# UNITED STATES PATENT AND TRADEMARK OFFICE

APPLICATION NO.	FILING DATE	FIRST NAMED INVENTOR	ATTORNEY DOCKET NO.	CONFIRMATION NO.
10/646,008	08/22/2003	Sung-Jae Moon	YOM-0048	8963
<div>7590 Cantor Colburn LLP 55 Griffin Road South Bloomfield, CT 06002</div>			<div>EXAMINER NGUYEN, HOAN C</div>	
			<div>ART UNIT 2871</div>	<div>PAPER NUMBER</div>
SHORTENED STATUTORY PERIOD OF RESPONSE		MAIL DATE	DELIVERY MODE	
3 MONTHS		01/30/2007	PAPER

<b>Office Action Summary</b>	<b>Application No.</b> 10/646,008	<b>Applicant(s)</b> MOON, SUNG-JAE	
	<b>Examiner</b> HOAN C. NGUYEN	<b>Art Unit</b> 2871

FIG. 6

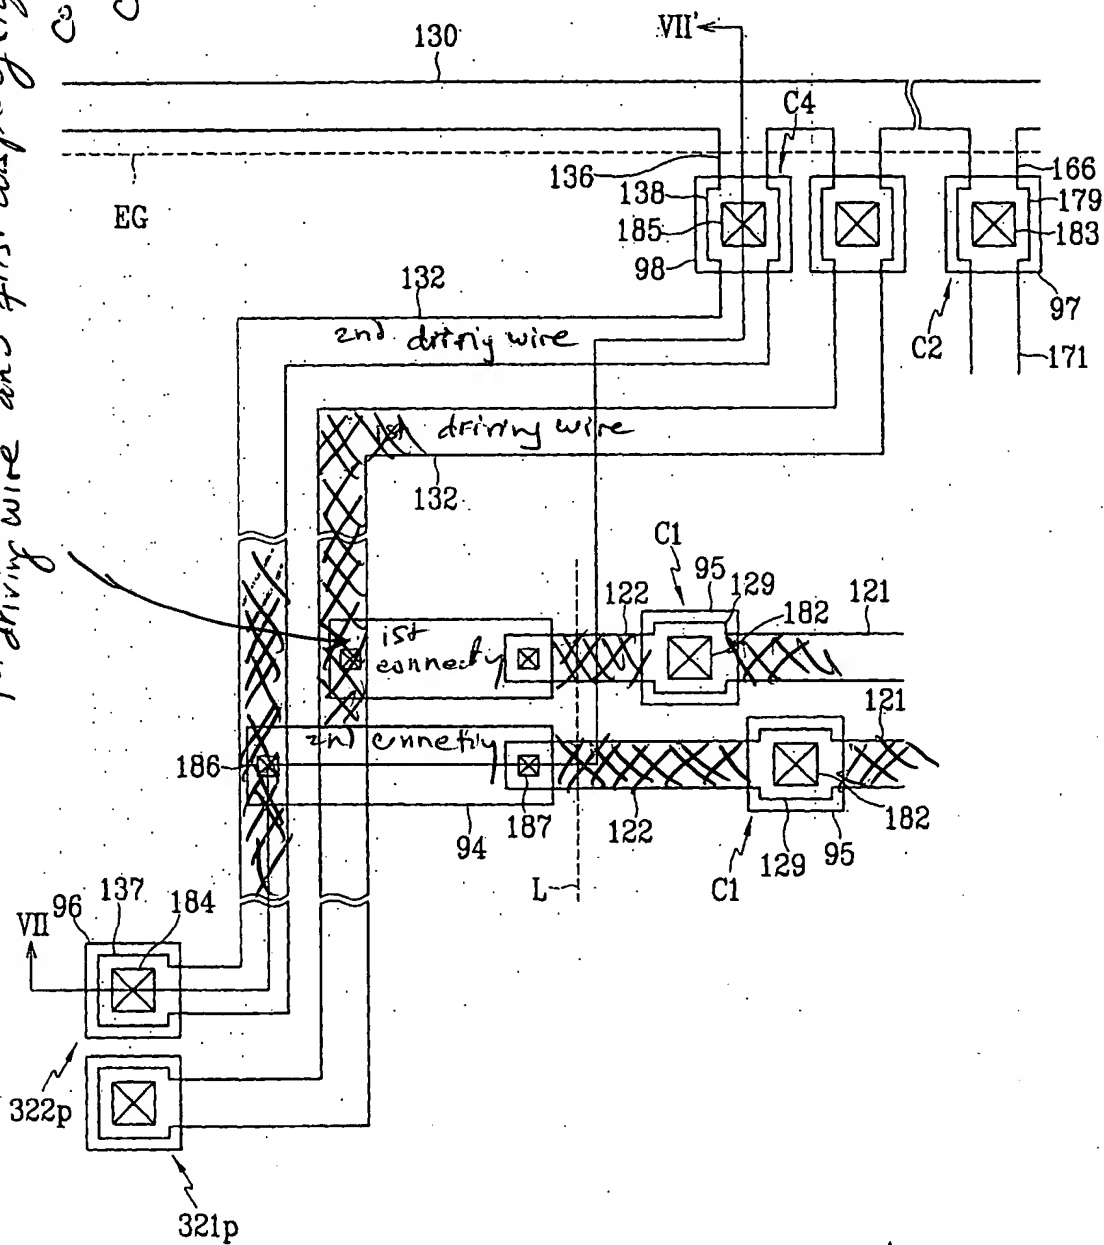
Examiner would like to thank applicants to clarify Fig. 3A and 6. However, Fig. 6 is an enlarged view of driving signal wire and shorting bar of Fig. 3A, but both two Fig. 3A and 6 still assign **the different designated numbers for the same elements**, examples:

- “driving signal wire” in Fig. 3A assigns with the designated numbers 321-322, but in Fig. 6, “driving signal wire” assigns with the designated numbers 132.
- “shorting bar” in Fig 3A assigns with the designated 320, but in Fig. 6 “shorting bar” assigns with the designated 130.

These designed numbers cause the confusion to exam the application. To avoid such confusion, please provide the Figures with assigning the different designated numbers for each of different elements. Do not assign the same number for different elements or do not assign the different numbers for the same element and be consistent the used designated numbers through all inventive drawings.

Fig. 6 shows the first connecting lines (the shorter/upper connecting member 94) disposed between the first driving wire and the first display signal wire 121, which connects to the first connecting lines (see attachment 1, shaded by blue pen).

Therefore, a part of the first display signal wire must be connects to the first connecting lines (the shorter/upper connecting member 94). The first connecting line (the shorter/upper connecting member 94) cannot be in between the first driving wire (shaded by blue pen) and the first display signal wire (shaded by red pen), which does not connect to the first connecting line.

Fig. 6 shows the second connecting line (the longer/lower connecting member 94) disposed between the second driving signal wire and the first display signal wire 121, which connects to the second connecting line (see attachment 1, shaded by red color pen). Therefore, another part of the first display signal wire must be connects to the second connecting line. The second connecting line (the longer/lower connecting member 94) cannot be in between the second driving wire (shaded by red pen) and the first display signal wire (shaded by blue pen), which does not connect to the first connecting line.

1<sup>st</sup> connecting line disposed between  
1<sup>st</sup> driving wire and first display signal wire, which  
connects to 1<sup>st</sup>  
connecting line
